Byron Station, Unit 2  
Facility Operating License Nos. NPF-66  
NRC Docket Nos. 50-455

Subject: Response to Request for Additional Information Regarding the Byron Station,  
Unit 2 Fall 2005 Steam Generator Inspection

**Additional Information Regarding the Byron Station Unit 2  
Fall 2005 Steam Generator Inspection**

**FIGURE 3-2**  
**Westinghouse Model D-5 Generator**  
**Byron Station Unit 2 Primary Separator Assembly**

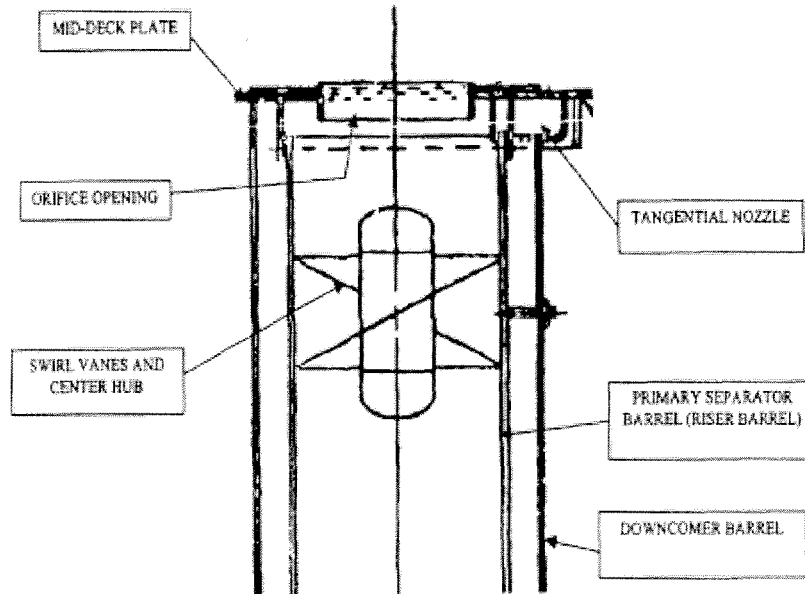
*In the staff's call summary, it was stated that a secondary-side visual inspection of the steam drum/moisture separator region of SG 2B was scheduled to be performed. Please provide the results of this secondary-side visual inspection.*

During the Byron Station Unit 2 B2R12 refueling outage, visual inspection of the 2B SG secondary side steam drum and moisture separator region was performed. All areas that were accessible through the upper secondary manways were visually inspected down through the lower deck plate (refer to Figure 3-1). The visual inspection included inspection of the following components:

During the visual inspection of the primary separator assembly region, areas were identified where the normally present magnetite layer was missing, thus providing areas for erosion to develop. The areas included portions of the tangential nozzles, portions of the inner surface of the primary moisture separator downcomer barrels, a number of primary separator swirl vanes, spacer tabs and orifice rings. Refer to Figure 3-2 for a sketch of these components. This condition existed on 12 of the 16 primary separator assemblies. The components identified with the missing magnetite layer are fabricated from carbon steel, typically American Society for Testing and Materials standard specification A-285, "Pressure Vessel Plates, Carbon Steel, Low and Intermediate-Tensile Strength," Grade C, material. The manufacturing nominal wall thickness for these components was 0.250-inch. To supplement the visual inspection observations, ultrasonic (UT) thickness measurements were taken in areas of magnetite loss with most apparent erosion.

Table 3-1 provides a summary of the UT thickness examinations performed on the most apparent eroded areas. Based upon the UT thickness examinations, the minimum material thickness loss observed and recorded was 0.183" on one swirl vane blade assembly. This represents a 27% reduction in material thickness.
